Access Compliance Report

Public Rights-of-Way

Intersection ID: 10013834	Main Street: IKEA_BV	Cross Street: N/A	Location: NW
ADA ID: 7DB360B3BAB8	Ramp Type: PerpDiag	Initial Pass/Fail: Fail	Overall Compliance: No
		Severity Score: 12.5

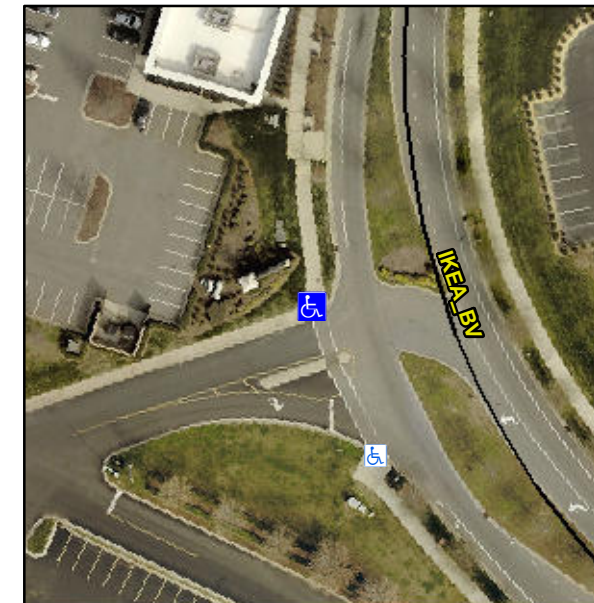
Not Found, R304.2.2

Compliance	Description	Data	Compliance	Description	Data
N/A	Ramp Length (in)	117.0	No	Ramp Slope (%)	9.2
Yes	Ramp Width (in)	48.0	Yes	Ramp XSlope (%)	1.2
N/A	Flare Type LT	N/A	N/A	Flare Type RT	N/A
N/A	Flare Slope LT (%)	N/A	N/A	Flare Slope RT (%)	N/A
N/A	Flare Traversable LT?	N/A	N/A	Flare Traversable RT?	N/A
N/A	Landing Length (in)	N/A	N/A	DWS Provided?	N/A
N/A	Landing Width (in)	N/A	N/A	DWS Contrast?	N/A
N/A	Landing Slope (%)	N/A	N/A	DWS Length (in)	N/A
N/A	Landing X Slope (%)	N/A	N/A	DWS Full Width?	N/A
N/A	Landing Curb? (Y/N)	N/A	N/A	DWS Offset (in)	N/A
N/A	Shared Landing?	N/A			
N/A	Gutter Ponding?	N/A	N/A	Gutter Slope (%)	N/A
N/A	Gutter Lip Ht (in)	N/A	N/A	Gutter X Slope (%)	N/A
N/A	Painted X Walk1?	Yes	N/A	Painted X Walk2?	No
	X Walk 1 Direction	To S		X Walk 2 Direction	To E
N/A	X Walk 1 Width (in)	81.0	N/A	X Walk 2 Width (in)	N/A
	X Walk 1 Slope (%)	2.0		X Walk 2 Slope (%)	0.2
	X Walk 1 X Slope (%)	2.1		X Walk 2 X Slope (%)	0.9

Remove & Replace Curb Ramp With Two New Directional Ramps or Equivalent.
